CONCEPT SITE PLAN OVERLAY - NOT FOR CONSTRUCTION - NOT A SURVEY

OPTION 1 - PLAN MIRRORED (GARAGE ON WEST, DRIVEWAY SIDE); HOUSE PARALLEL WITH SIDE LOT LINES

EXISTING CONDITIONS PLAN

LOCATION: 199 CENTRAL STREET

SHEET 3 - ORIENTATION STUDY: PARALLEL WITH THE LOT vs. SQUARE TO CENTRAL STREET

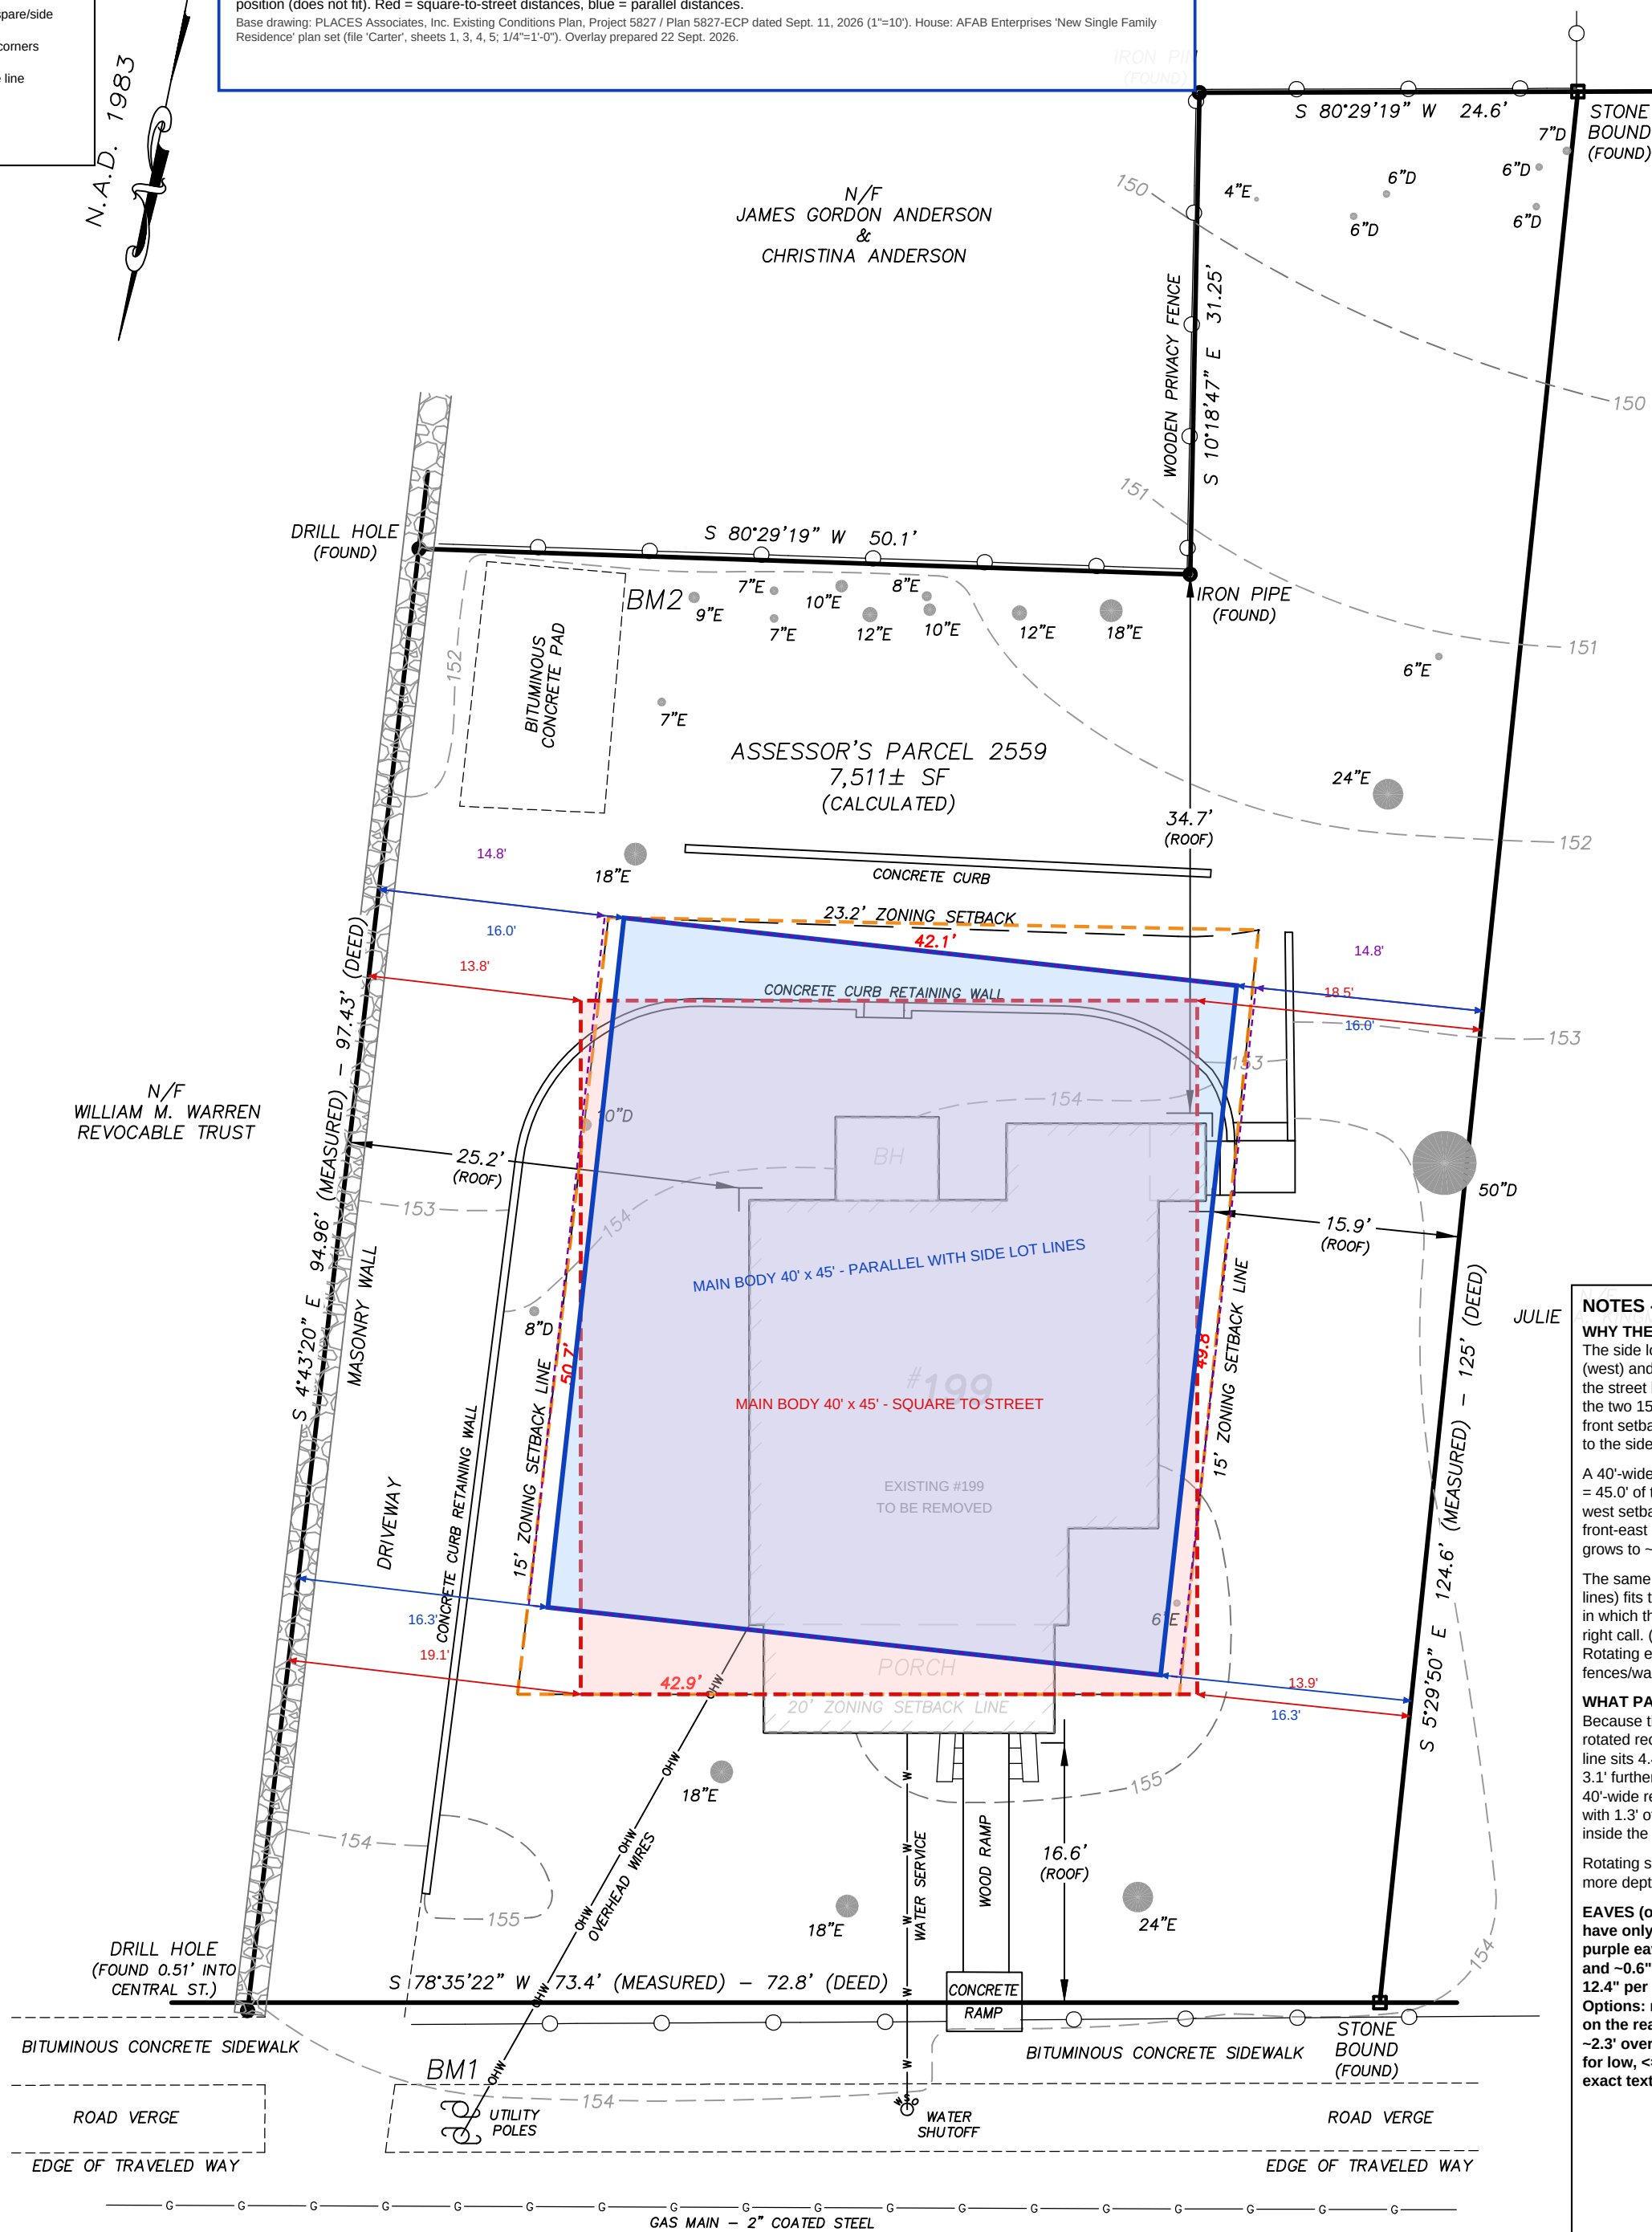
WHY THE HOUSE SHOULD BE PARALLEL WITH THE SIDE LOT LINES
The side lot lines are not square to Central Street: on the ECP they lean 6.7 deg (west) and 5.9 deg (east) toward the east as they run away from the street, while the street line runs straight across the sheet. The buildable envelope between the two 15' side setback lines is therefore a slanted strip: 42.9' wide along the front setback line and 42.1' along the rear one, i.e. about 42.4' measured square to the side lines.

A 40'-wide house set SQUARE TO THE STREET needs 40' + 45' x tan(6.3 deg) = 45.0' of that strip over its 45' depth, so it cannot fit: at best it is ~1.1' over the west setback line at its rear-west corner and ~1.1' over the east line at its front-east corner (red). Add the 7'-6\"/>

The same house ROTATED 6.3 deg (parallel with the mean bearing of the side lines) fits the strip with ~1.0' to spare on each side (blue). It is the only orientation in which the 40' width clears both 15' side setbacks, so 'parallel with the lot' is the right call. (The existing house is square to the street, but it is only 27.5' wide.) Rotating exactly parallel also keeps the house visually consistent with the side fences/walls; the ~6 deg skew to the street is barely perceptible from the road.

Because the front and rear setback lines are not square to the rotated house, the rotated rectangle loses depth at opposite corners: across the 40' width the front line sits 4.4' further 'back' at the east end than at the west end, and the rear line 3.1' further 'forward' at the west end than at the east. Net effect: a rotated 40'-wide rectangle can be at most ~46.3' deep on this lot. The 45' main body fits with 1.3' of side; the 7'-6\"/>

Rotating slightly less than parallel (about 5.5 deg) trades side clearance for ~0.5' more depth - not enough to matter. Exactly parallel is recommended.
